Los Angeles Conservancy Comment Review

Regarding: Barry Building (11973 San Vicente Boulevard, Los Angeles, CA 90049)
Los Angeles Conservancy Comments Review

ASCE 41-13 Seismic Assessment

Figure 7.1: Conceptual Shear Wall and Steel Moment Frame Locations

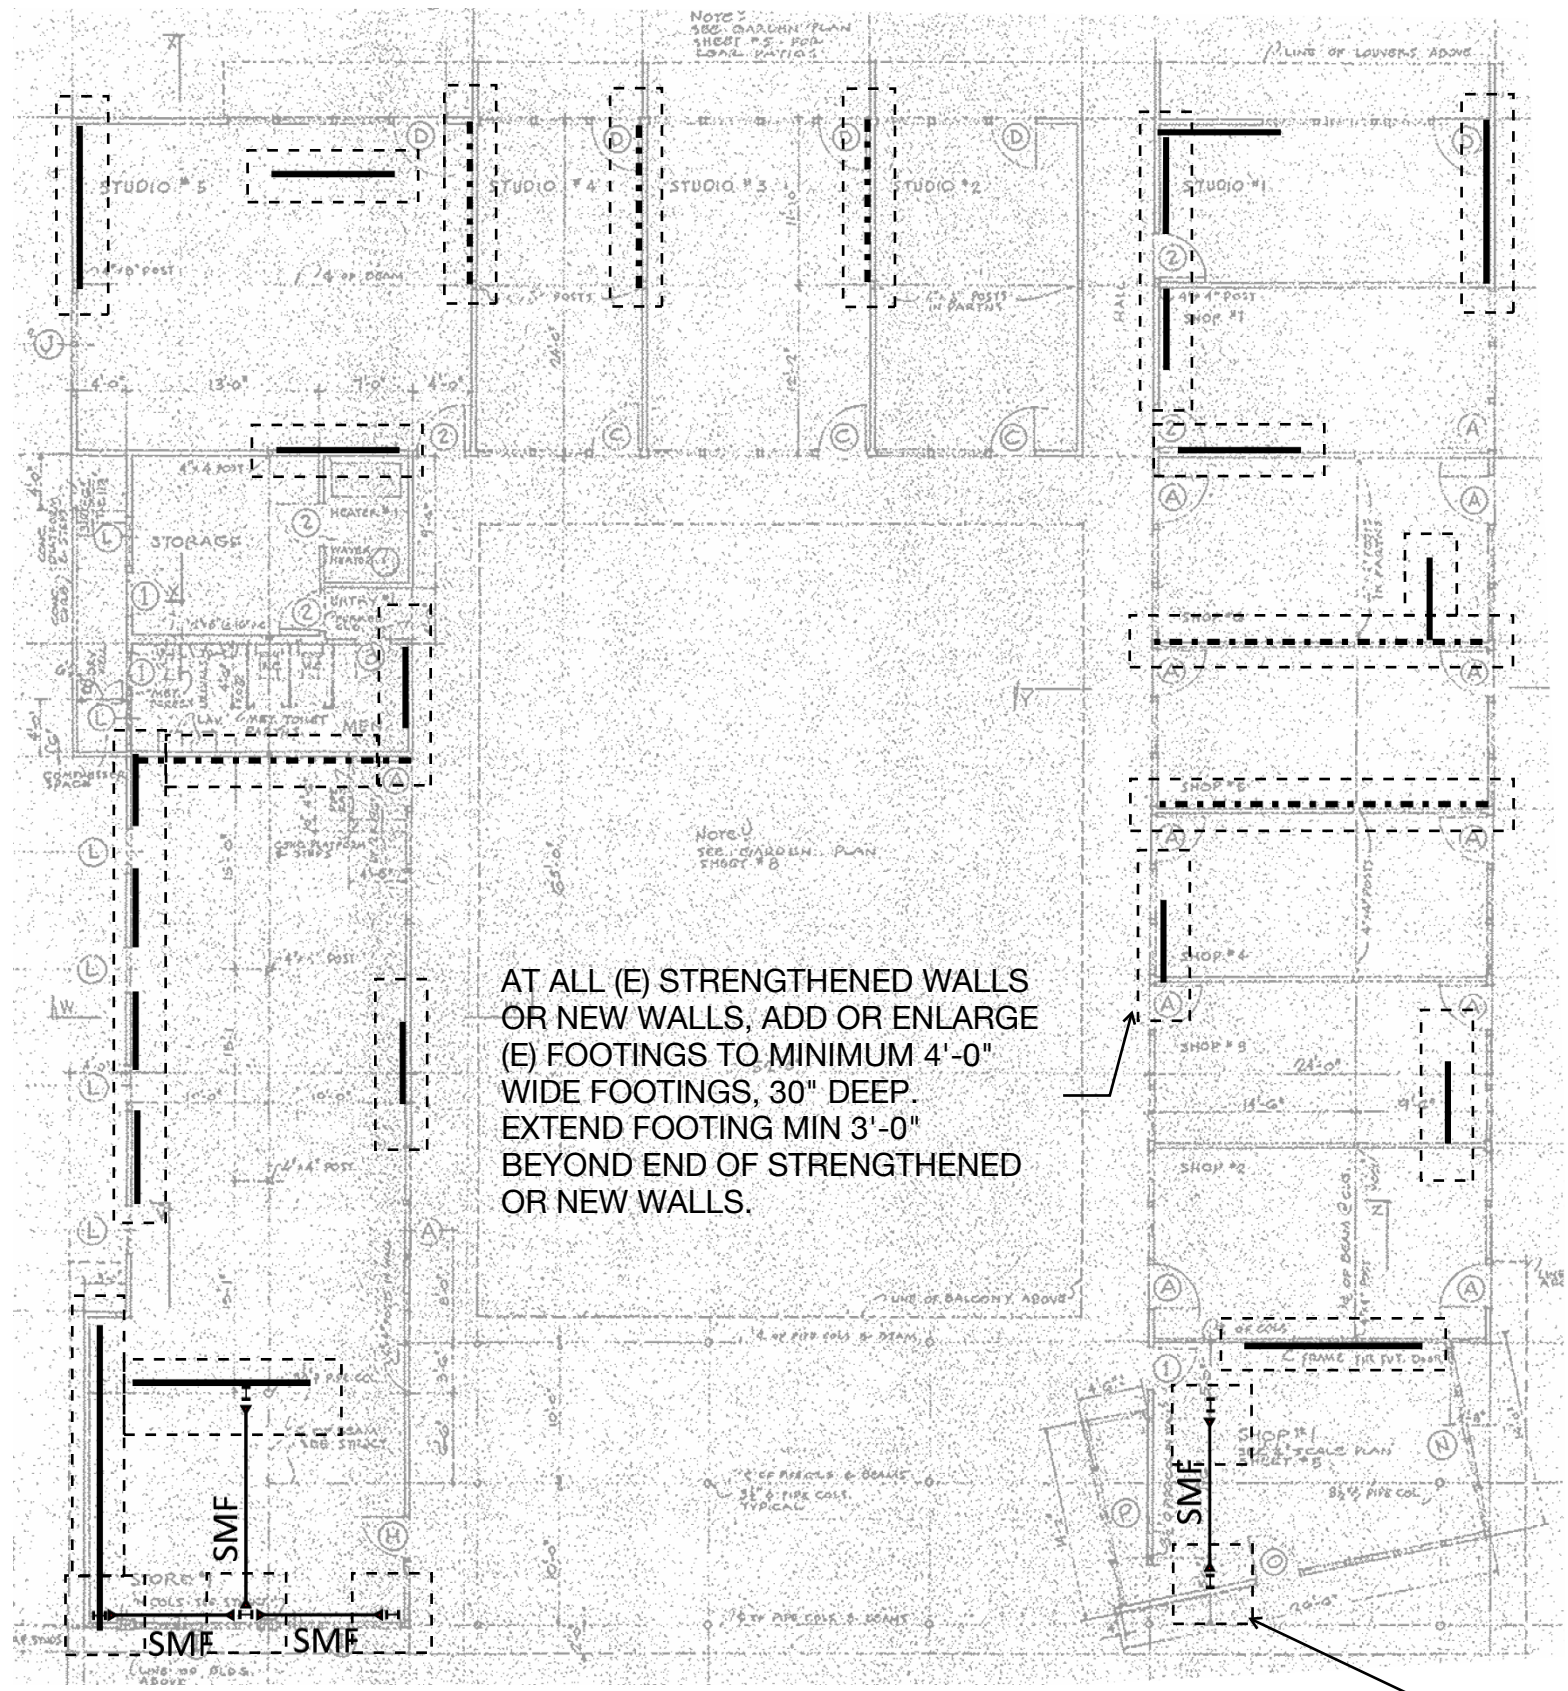
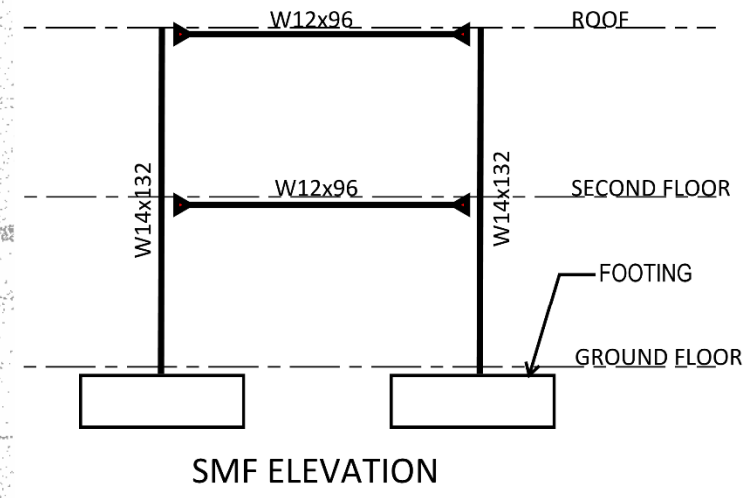
A substantial portion of the seismic retrofit work identified in the reports would still be needed if the seismic requirements in the California Historical Building Code were applied. Under that Code, a historical building shall be retrofitted to meet 75% of the current building code forces. However, due to the very high level of overstress in the building, 230% to 650% in the structural members, a substantial portion of the work would still be required. Strengthening of existing shear walls and floor/roof plywood diaphragm, additional shear walls and moment frames would still have to be added.

To conform to the seismic force resisting requirements for a new structure, we propose a seismic retrofit scheme that includes strengthening the existing walls, adding new 2-story shear walls, and new steel moment frames. (See Figure 7.1 for conceptual shear wall and steel moment frame locations)

The existing shear walls need to be continuous between floors. The strengthening requirements include adding new plywood sheathing and nailing, new hold-down anchors at each end of the wall, new floor to wall connection, and new footing/enhancing for the existing footing.

New Shear Wall: New wood shear walls need to be continuous between floors. The new wood shear wall construction includes new 2x stud wall framing, new plywood sheathing and nailing, new hold-down anchors at each end of the wall, and new footing.

New Floor and Roof Diaphragm Sheathing: New $\frac{3}{4}$ " plywood sheathing over the entirety of the existing floor and roof sheathing.

Steel Moment Resisting Frame: Two-story steel moment resisting frames are to be introduced at the south wing where no continuous shear wall may be feasible. The steel moment resisting frames consist of new wide flange steel columns, wide flange steel beams, and new concrete footings.
